PLANNING, ZONING, & BUILDING DEPARTMENT
PZ&B Staff Memorandum: Landmarks Preservation Commission

SUBJECT: COA-24-012 335 EL VEDADO RD

COA-24-012 (ZON-24-055) 335 EL VEDADO RD - COMBO. The applicant, Diana Wister, has filed an application requesting a Certificate of Appropriateness for the review and approval for the demolition of an existing outdoor terrace for the addition of a one-story addition requires one (1) variance to reduce the rear yard setback. This is a combination project that shall also be reviewed by the Town Council as it pertains to zoning relief/approval.

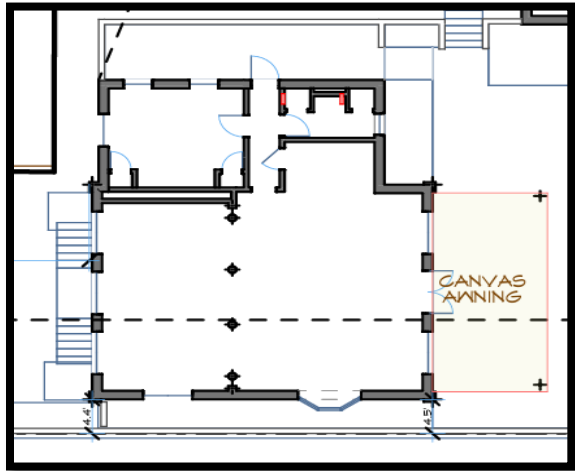
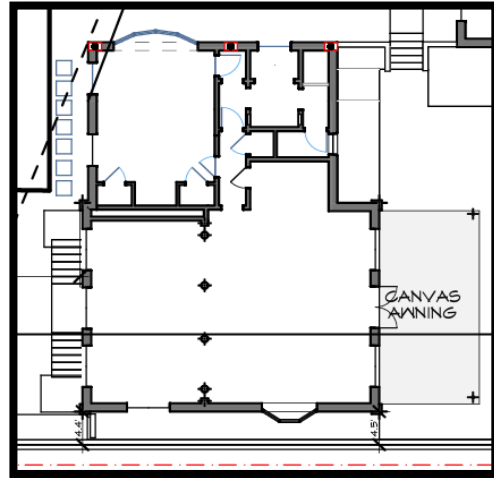
Although the proposed addition does not trigger any zoning relief independently, the existing north side of the cabana does not meet the required setbacks for the rear yard of 15’. Due to the loss of more than 50% of the existing structure, the applicant must request a variance to maintain the existing nonconformity.

The application is seeking a Certificate of Appropriateness for the expansion of an existing pool cabana built in 1959. The variance request serves only to maintain the existing north elevation which staff has no objection to. The proposed addition is in keeping with the architectural style of the existing pool cabana and main residence.
